RESPONSE TO SUBMISSIONS LETTER - TRAFFIC/VEHICLE MOVEMENTS

TTPP REF: 16222

RE: Proposed Resource Recovery Facility, 20 Hearne Street Mortdale (SSD 7421)
Response to Submissions

Driveway Access Vehicle Swept Paths

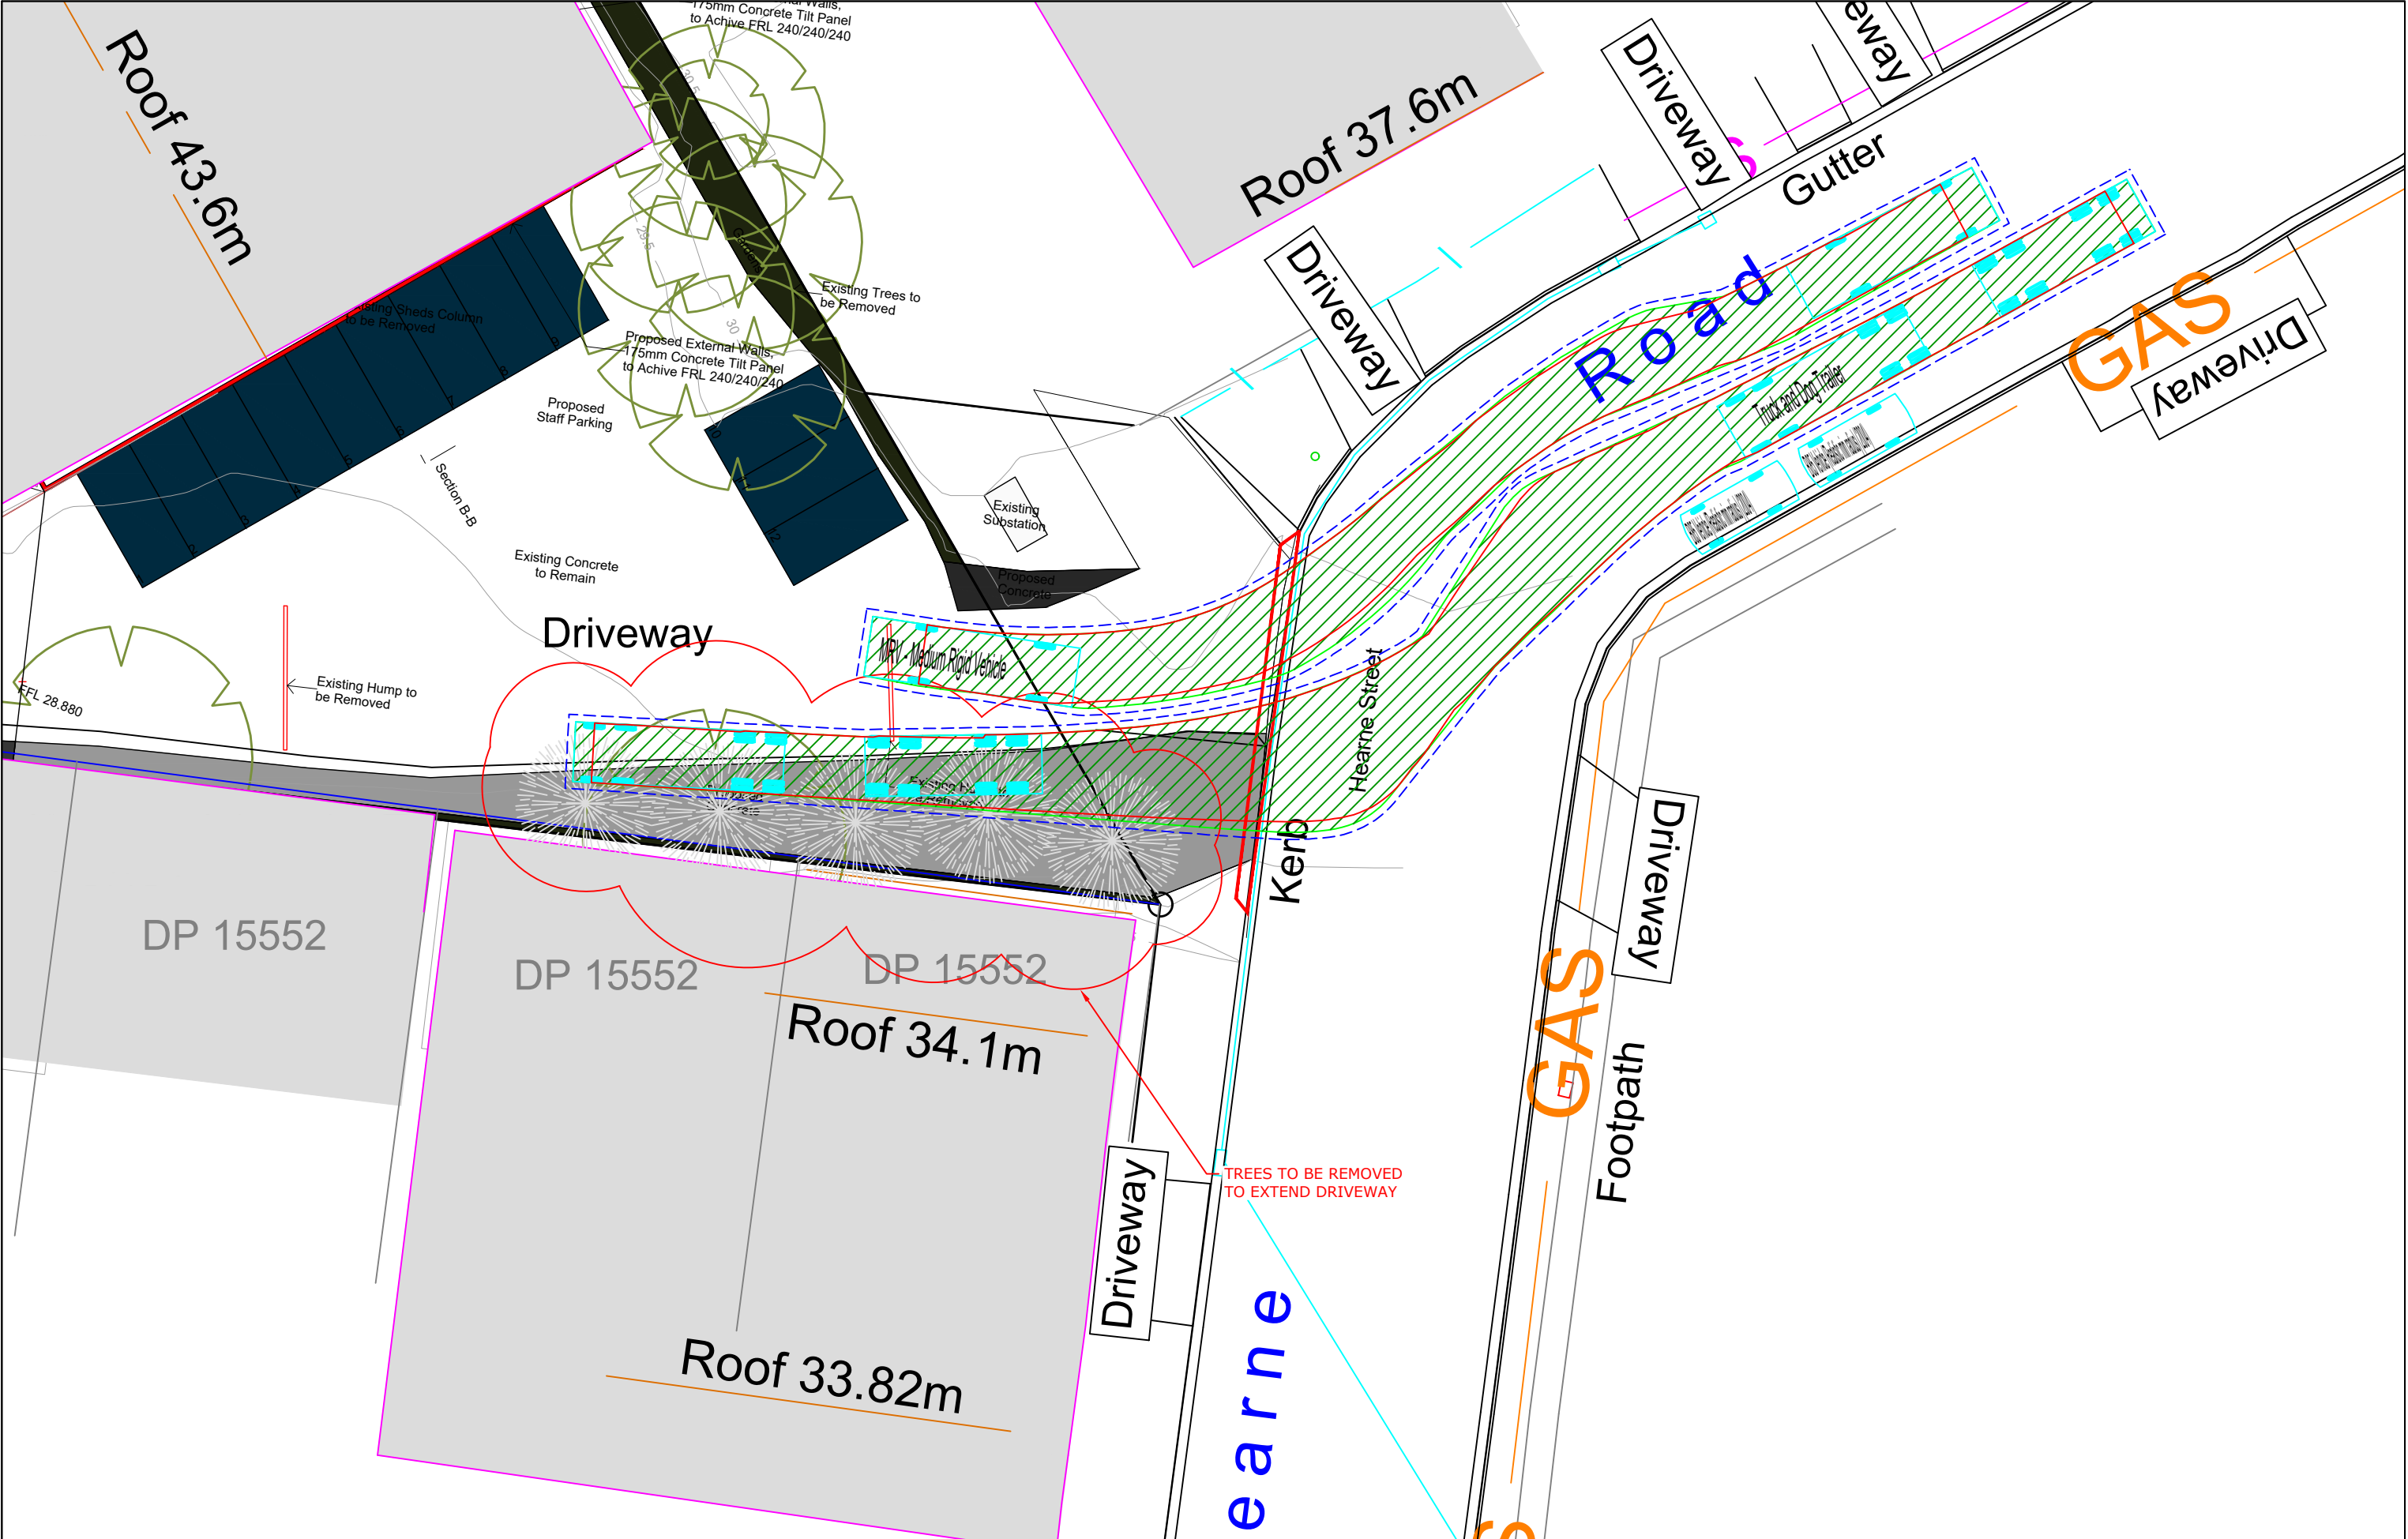
Exiting trucks have been placed in a location which contradicts the stacking plan diagrams. This requires amendment.

The stacking plan has been amended accordingly, and is provided in Attachment B and Attachment C. Vehicle swept paths at the site access are shown in greater detail in Attachment D.
